NORTHSIDE INDEPENDENT SCHOOL DISTRICT

ADDENDUM No. 1

PROJECT NAME: **PAVING AND DRAINAGE UPGRADES AT MEADOW VILLAGE ES**

RFCSP# **2025-027**

PROPOSED SITE/GRADING PLAN AREA "B"

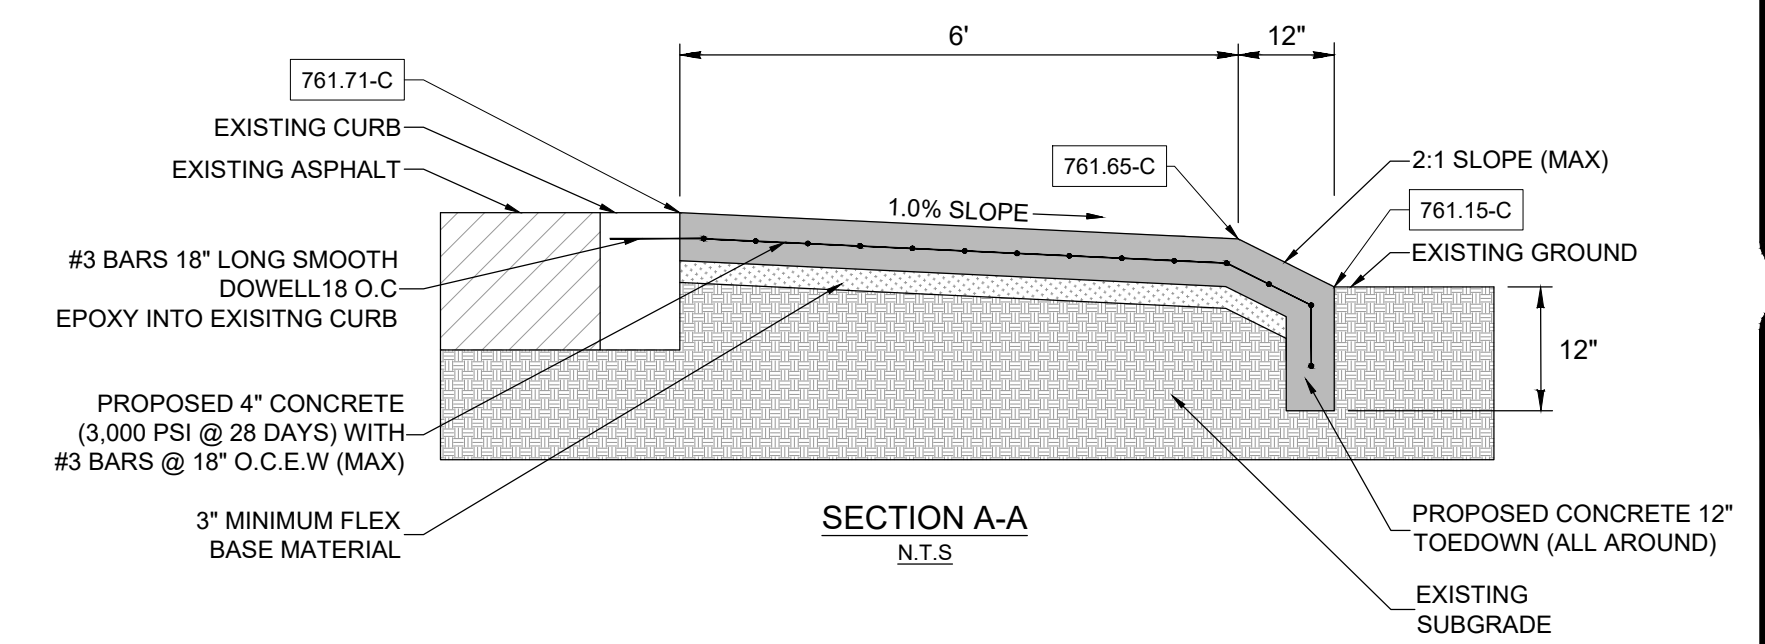
1. Sheet 8 OF 15 Proposed Site/Grading Plan Area "B": Private Fire Hydrant shown.

Date: _____
 Revisions/Submissions: _____
 SHOW LOCATION OF PRIVATE FIRE HYDRANT

PROPOSED SITE/GRADING PLAN AREA "D"

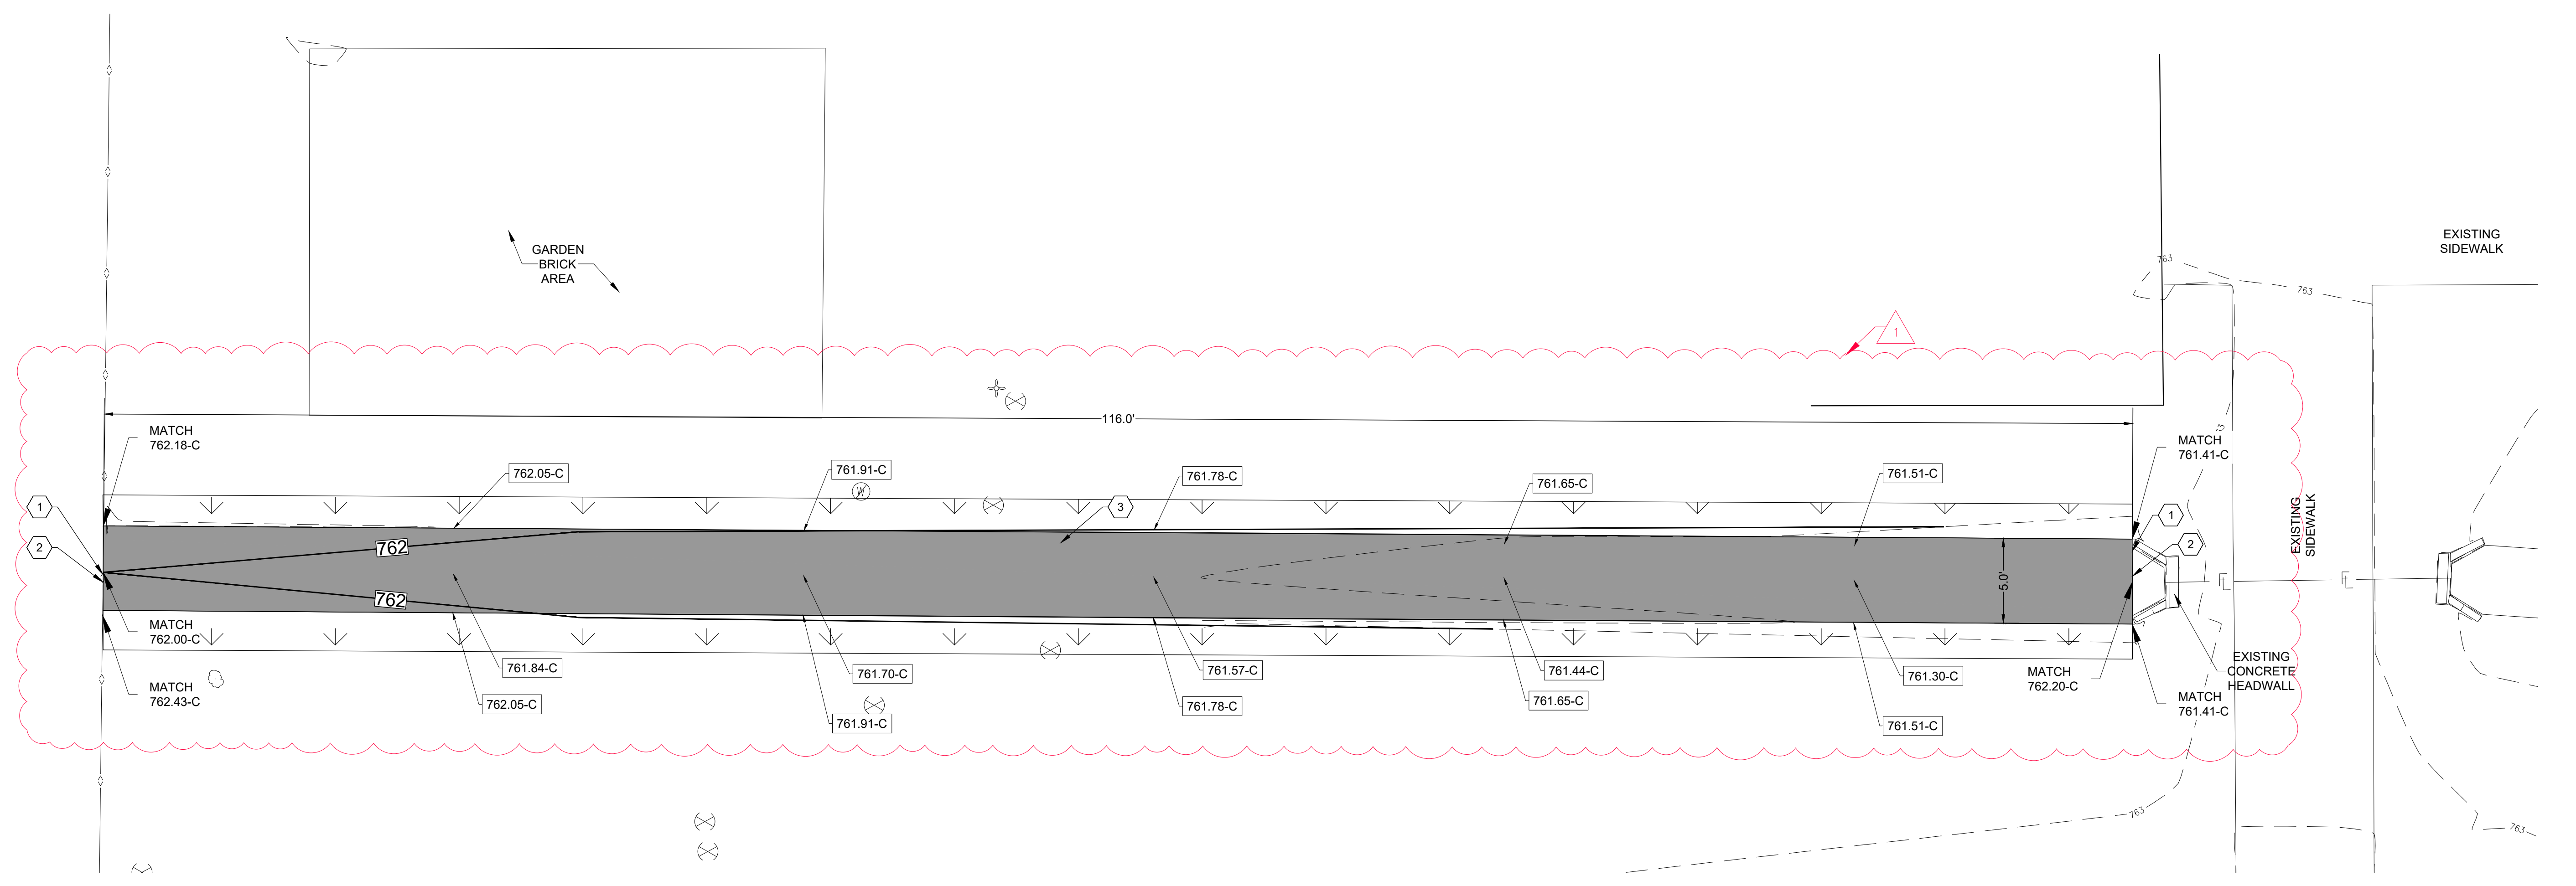
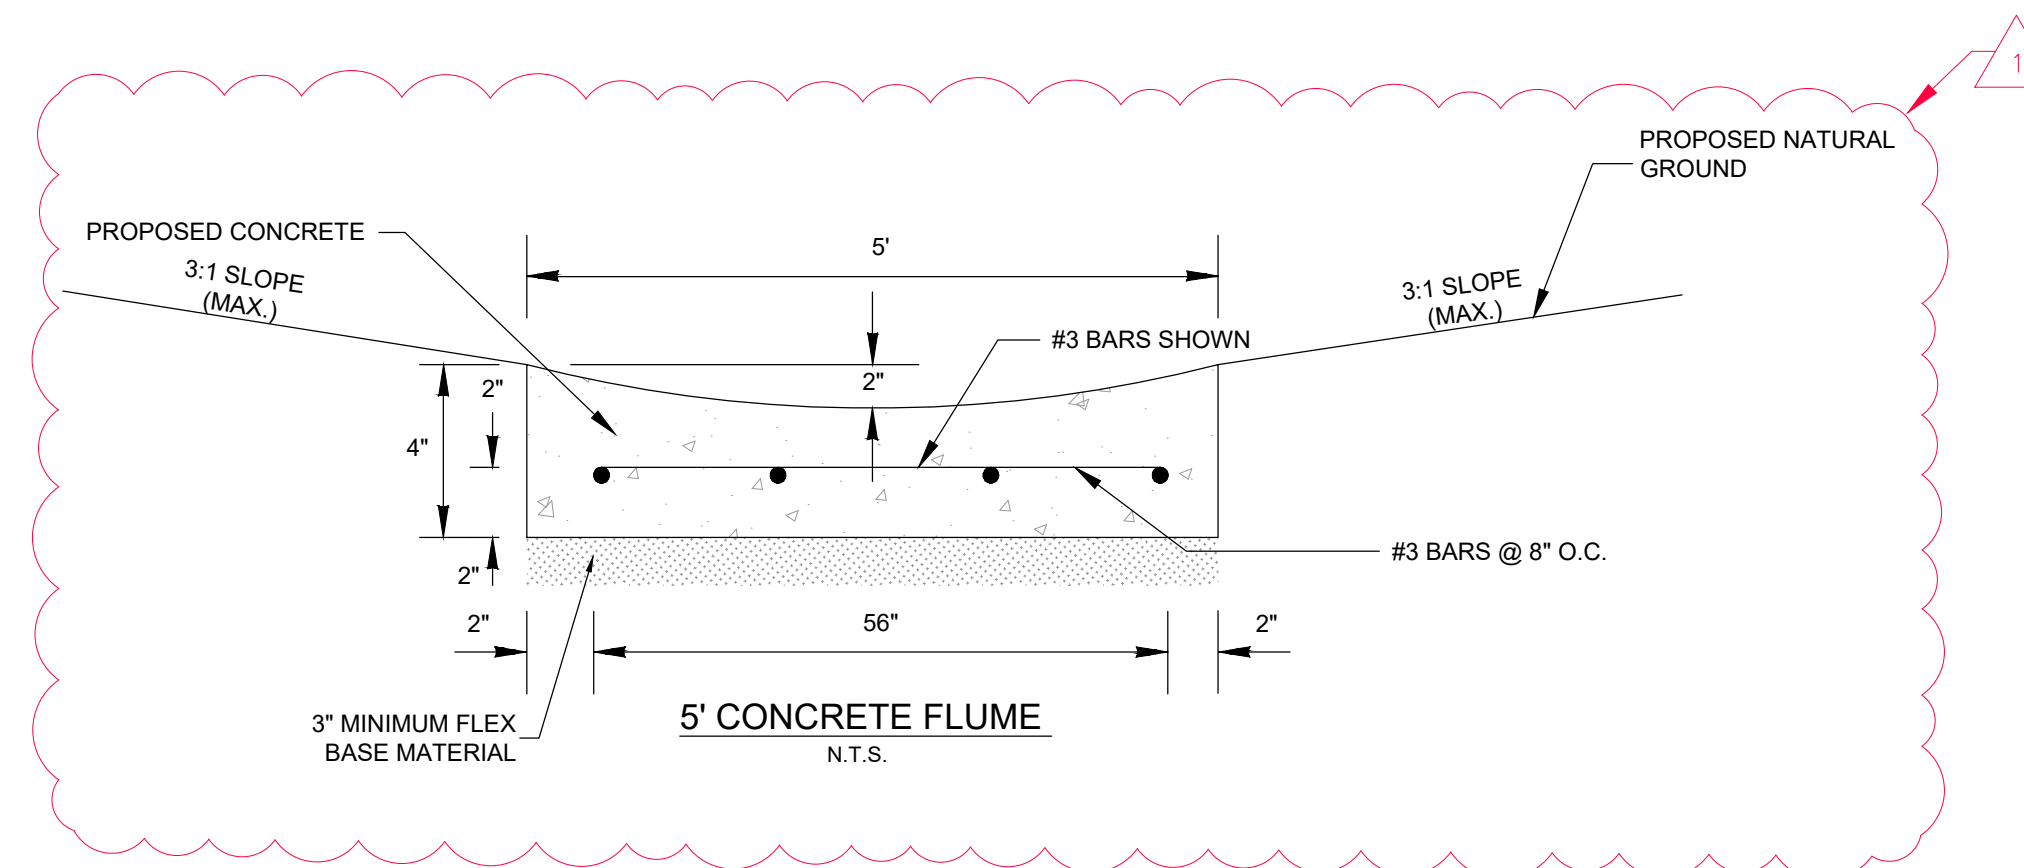
1. Plan area D shows no topsoil or sod, does it not get sod there?

2. Sheet 10 OF 15 Proposed Site/Grading Plan Area “D”: Limits of topsoil and sod shown, and concrete flume detail updated.
3. Sheet 11 OF 15 Proposed Site/Grading Plan Area “E”: Specified work to be completed at cleanout shown.
4. Sheet 15 OF 15 Civil Details: Added In-Line Cleanout details.

Date:	Description:
2/26/25	ADDED DIMS OF TOPSOIL AND SOILING AND UPDATED CONCRETE FLUME DETAIL

Response: Sod and topsoil will be required for area D. See sheet 10 of 15.

PROPOSED SITE/GRADING PLAN AREA "E"

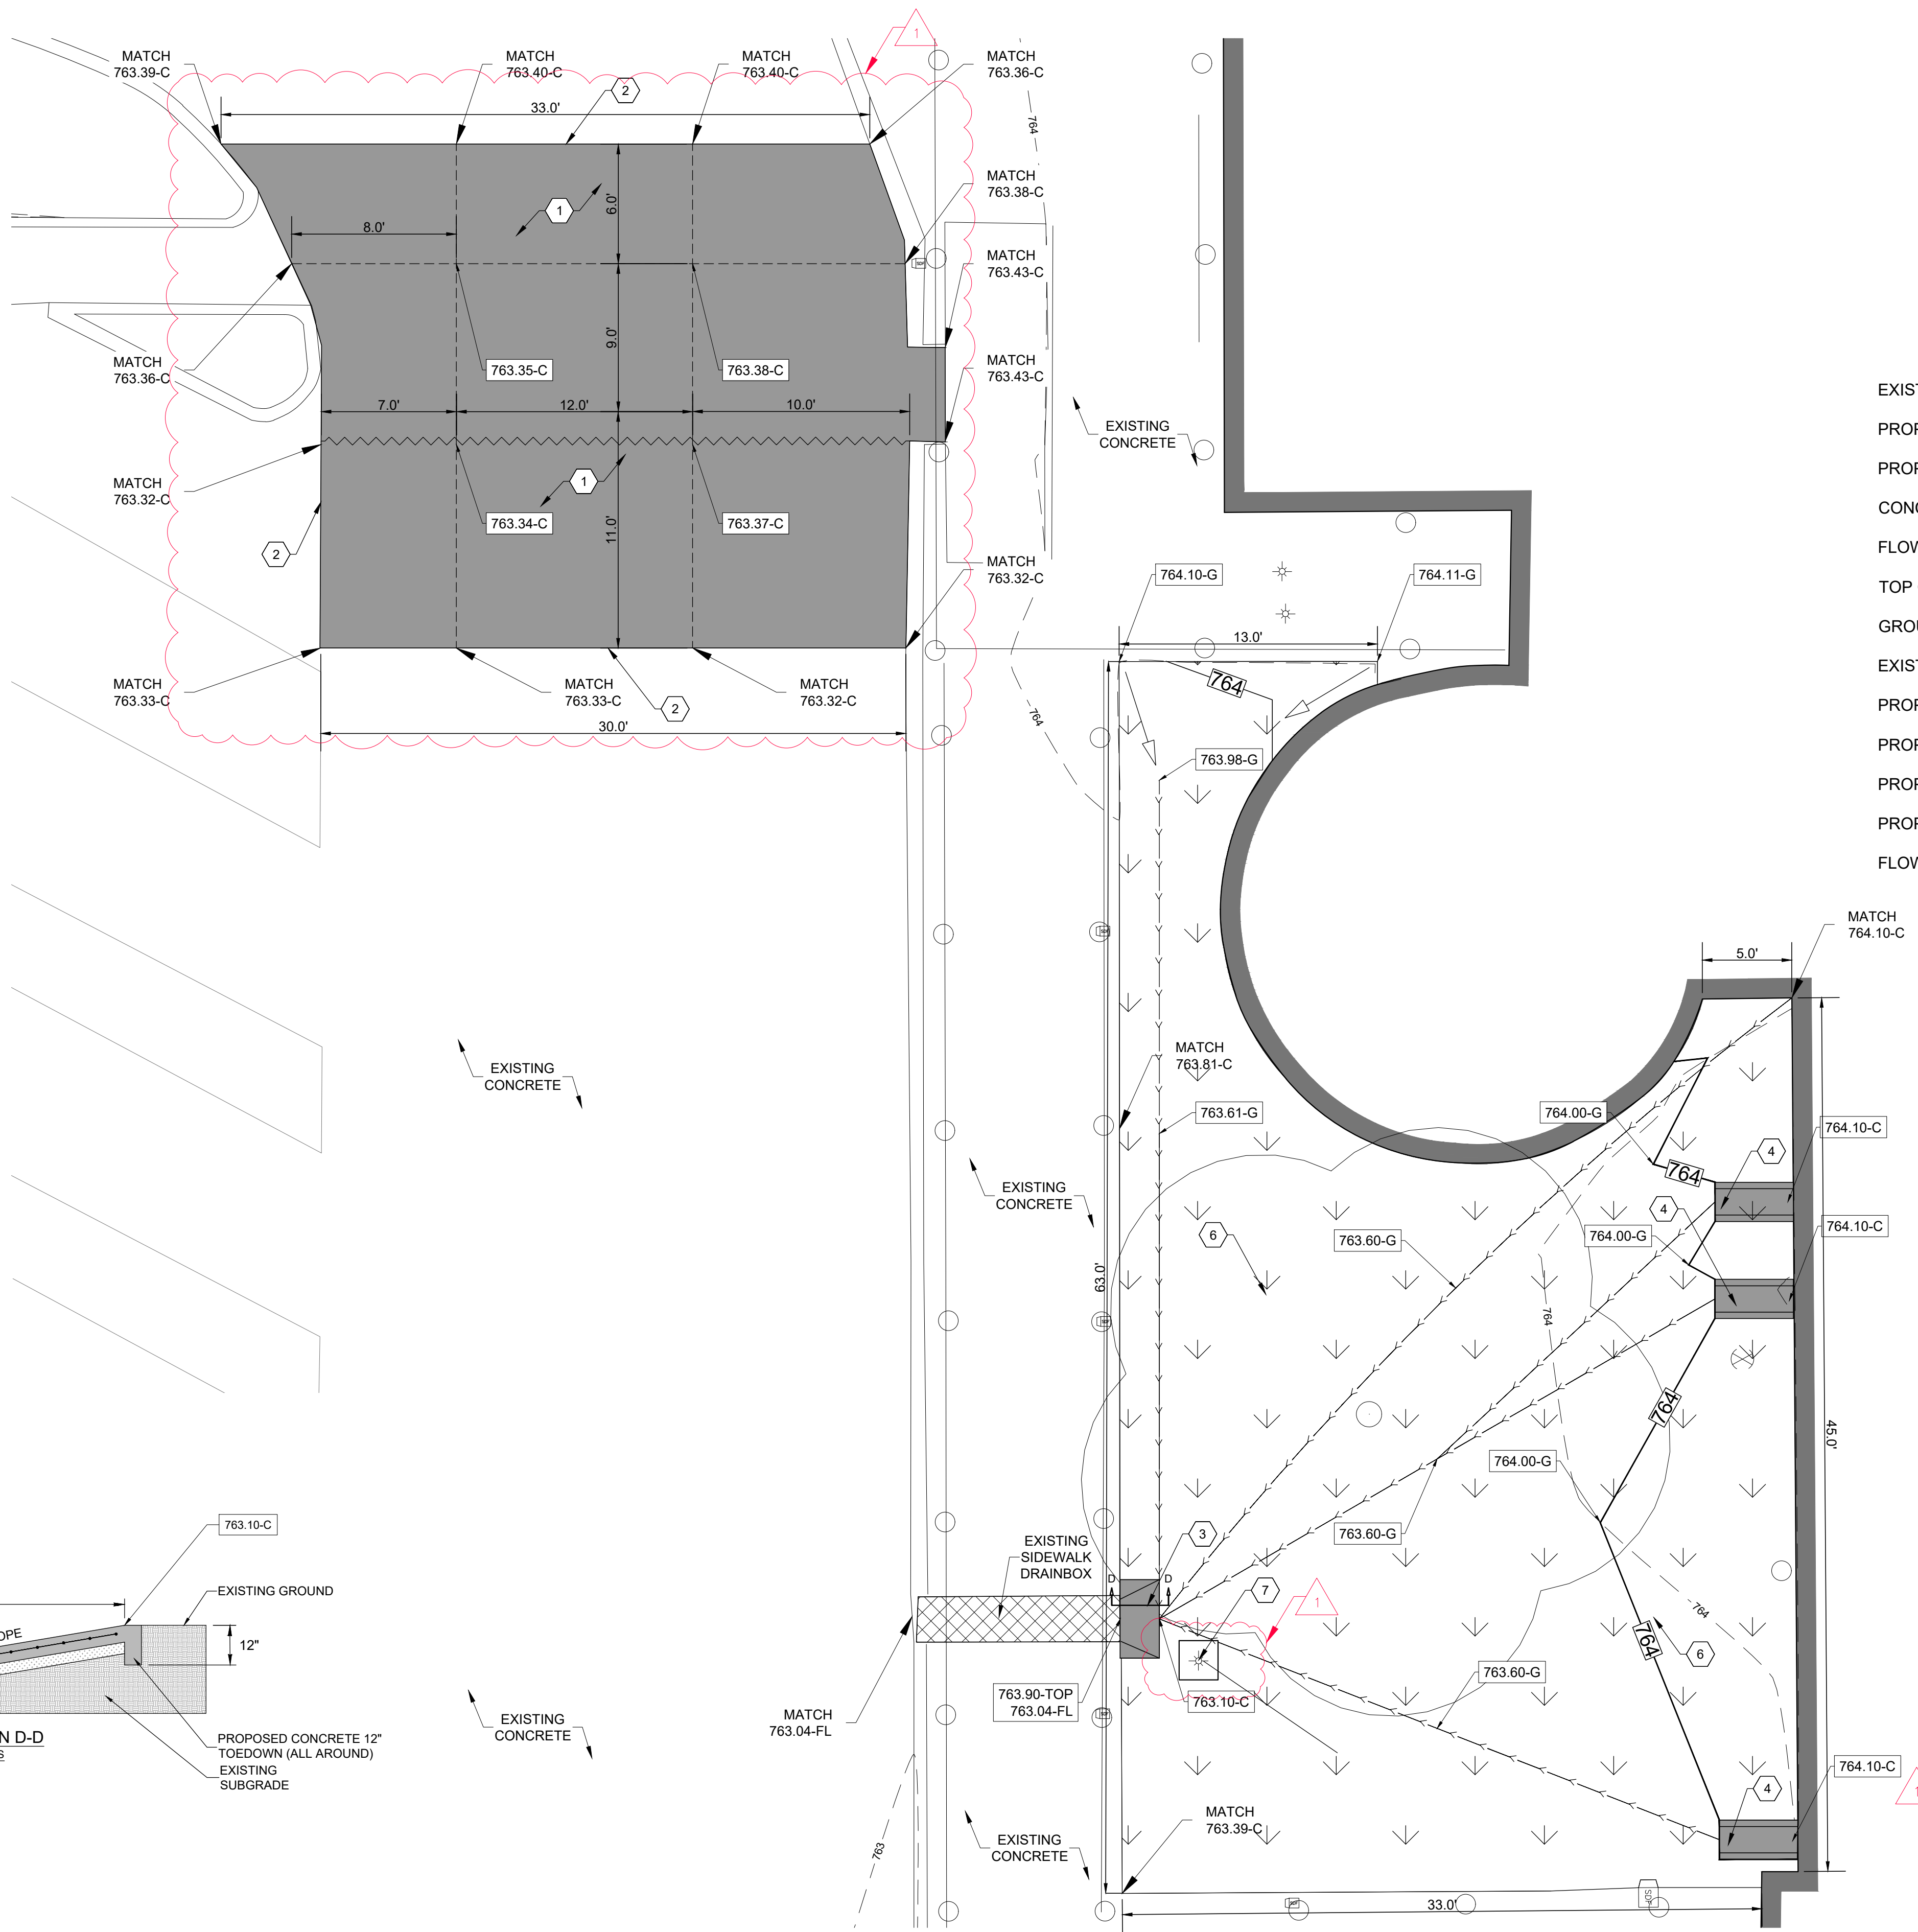
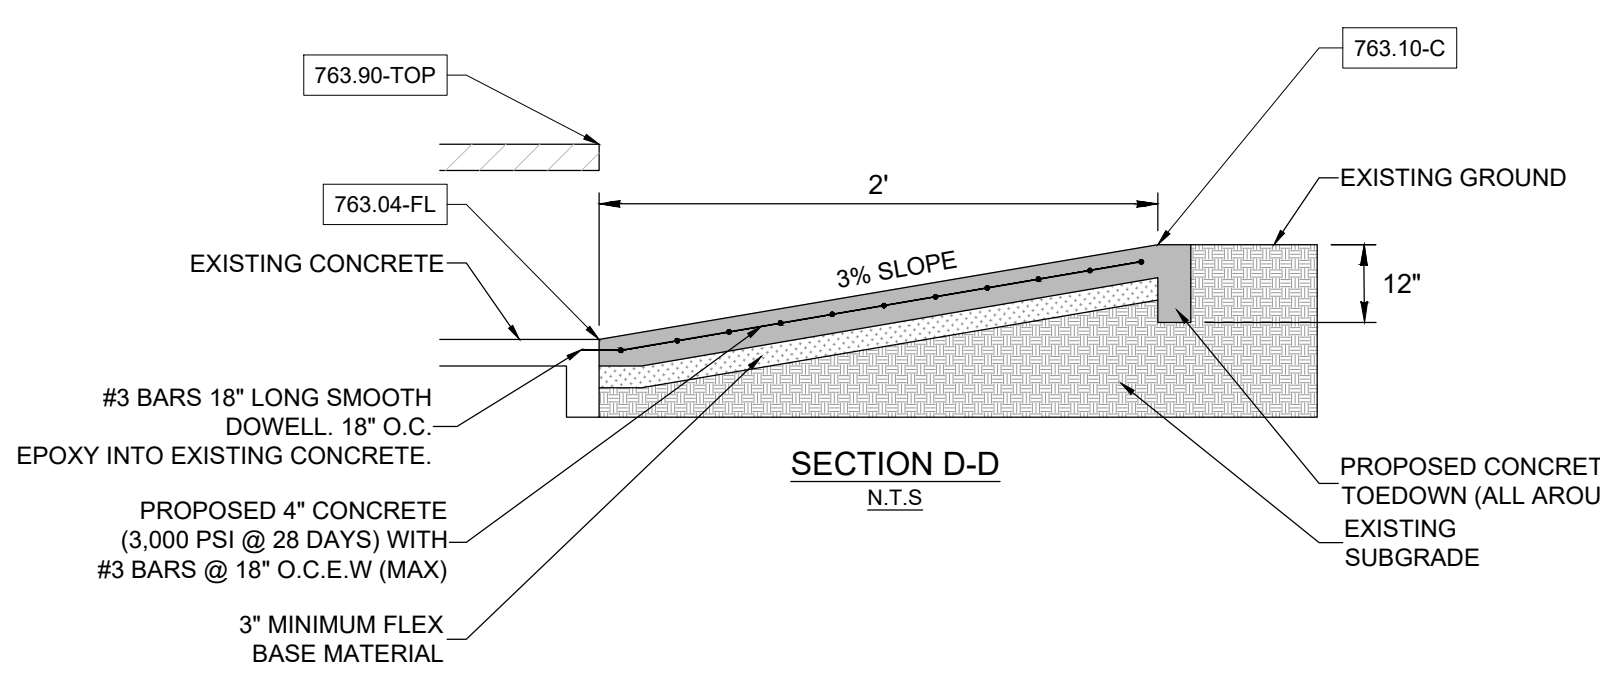
Date:	Description:
2025-02-27	SPECIFIED WORK TO BE COMPLETED AT CLEANOUT
